REDEVELOPMENT AGENCY OF CENTERVILLE CITY AGENDA

Short Title: Bank of America - Conceptual Site Plan

**STAFF REPORT
AGENDA: ITEM 3**

OWNER:	DEERWOOD INVESTMENTS UTAH LLC 3720 SOUTH SUSAN STREET #100 SANTA ANA, CA 92704 msalcedo@acpmanagement.com
CONTACT:	ORLANDO TAYOR orlando_taylor@gensler.com
PARCEL:	782 WEST PARRISH LANE (AKA: FORMER IGGY'S BUILDING- ISLAND PARCEL)
ACREAGE:	1.0 ACRES
ZONING:	COMMERCIAL – VERY HIGH (C-VH)
APPLICATION:	CONCEPTUAL SITE PLAN ACCEPTANCE (<i>SITE PLAN AMENDMENT</i>)

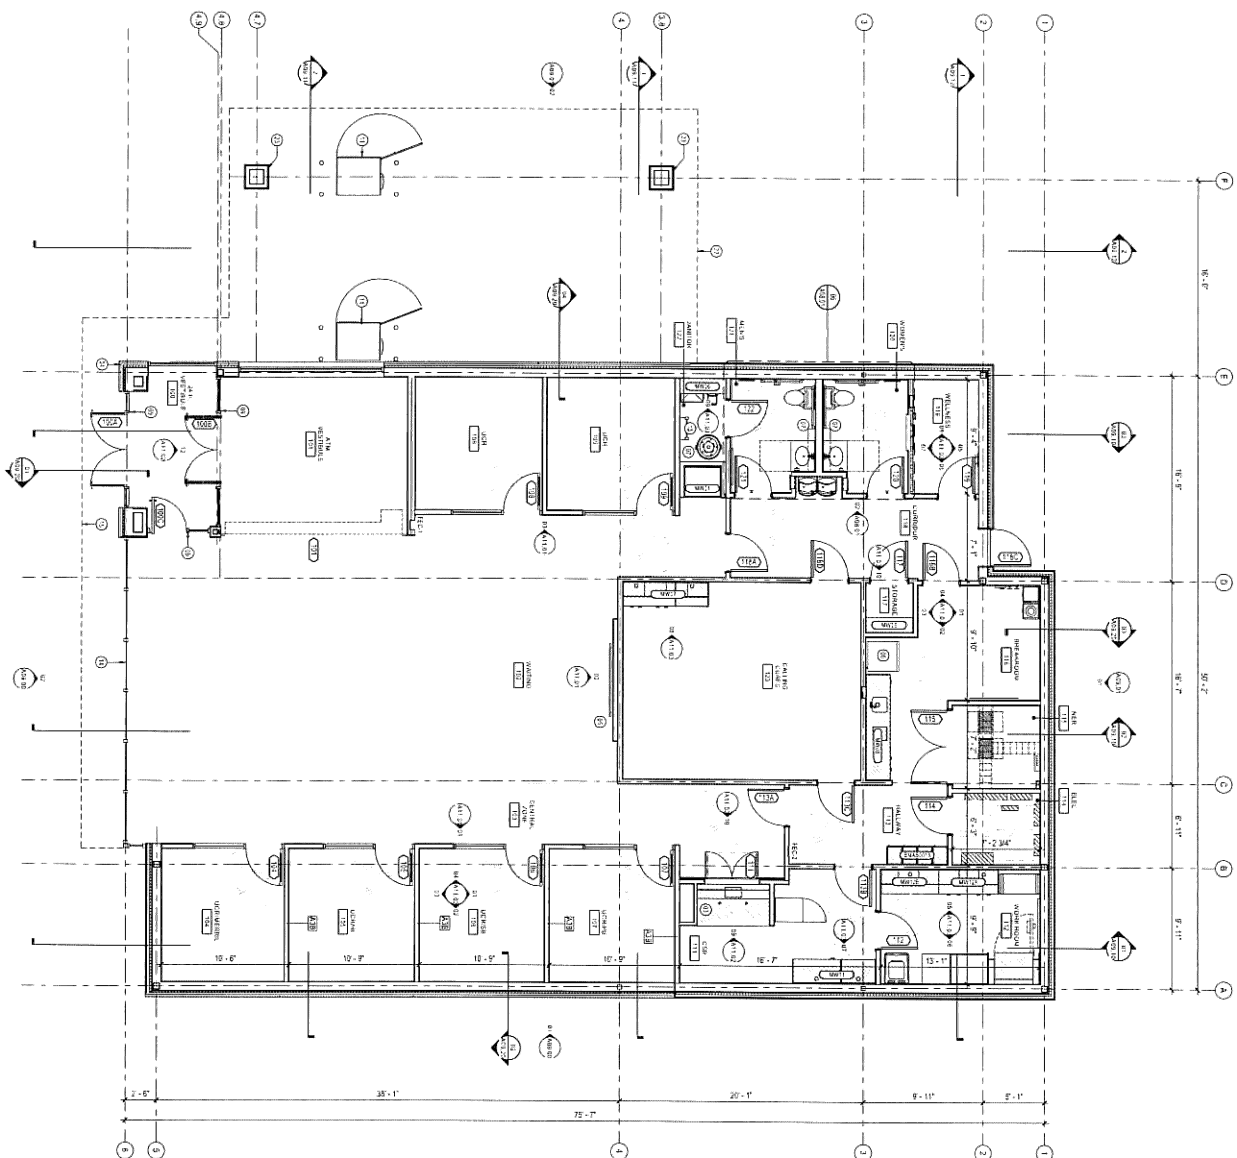
At least 15% of the project must be landscaped and 7% internal parking lot landscaping. The conceptual proposal depicts 25% for the site and 9.8% for the parking lot (see Sheet L1.1 of Submittal). It appears that the required number of trees and shrubs are being installed for the internal parking lot reconfiguration.

The site is required to provide one (1) parking space for every 200 square feet of gross floor area, plus two spaces, which would require a minimum of 22 spaces for the proposed development. The conceptual plan depicts a total of 41 on-site parking stalls. Bank uses are required to have a minimum of three (3) stacked parking spaces for each drive-through lane [see CZC 12.52.(d)]. The stacked parking has NOT been dimensioned on the submitted site plan. The two-way drive isles need to be corrected from 24 feet to the Zoning Code required 25 feet in width (see CZC 12.52.310).

- c. The two-way drive isles need to be corrected from 24 feet to the Zoning Code required 25 feet in width (see CZC 12.52.310).*
 - d. The Final Site Plan shall address the required "storyboard" regarding the use of colors, materials, expected articulation parameters and design features (see CZC 12.63.040).*

EXTERIOR ELEVATION - SOUTH

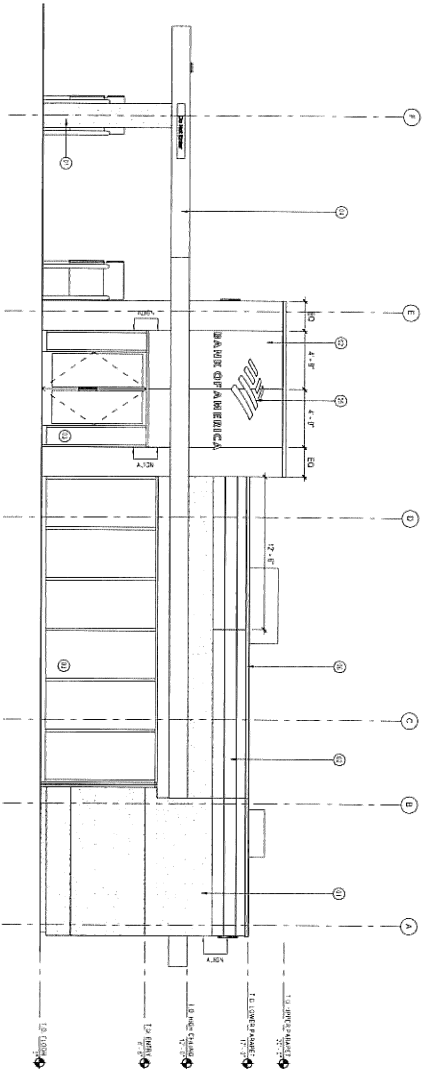
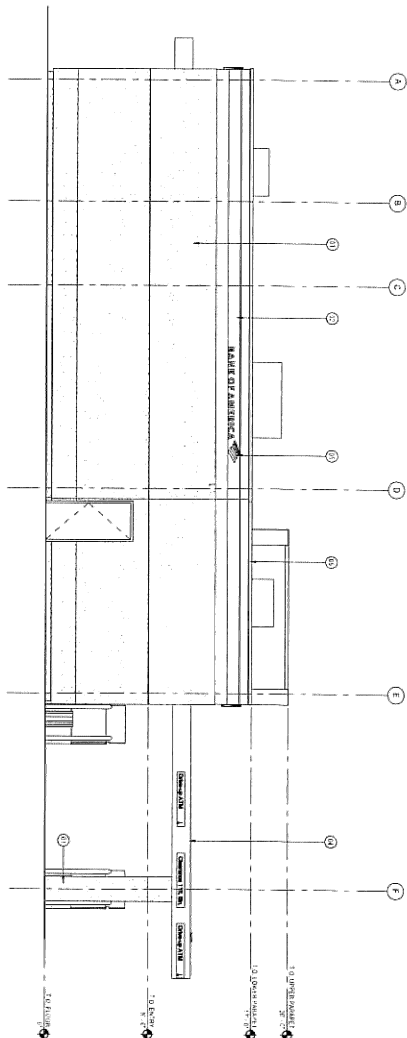
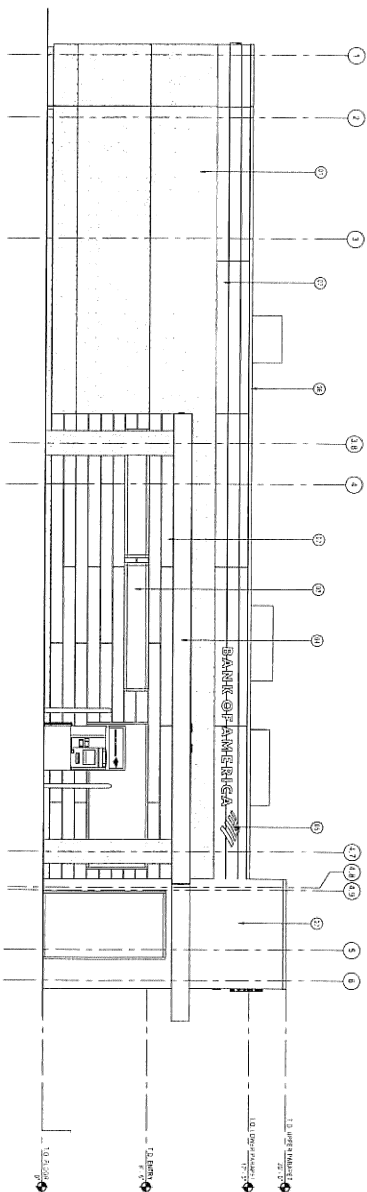
Staff Conclusion – The submittal is missing the required “storyboard” regarding the use of colors, materials, and the expected articulation parameters (*see CZC 12.63.040*). Staff is not convinced that the new design has sufficient articulation in the building. However, it’s a rather small building, where larger buildings are the prominent focus for implementing expected articulation. Nonetheless, any main building must include the expected upgraded features as outlined in CZC 12.63.040(c)(2).

Staff Conclusion – As mentioned earlier, any roof top equipment or ground based utility equipment “shall” be screened with compatible screening elements of the building’s architecture. The conceptual site plan submittal does not address this requirement.
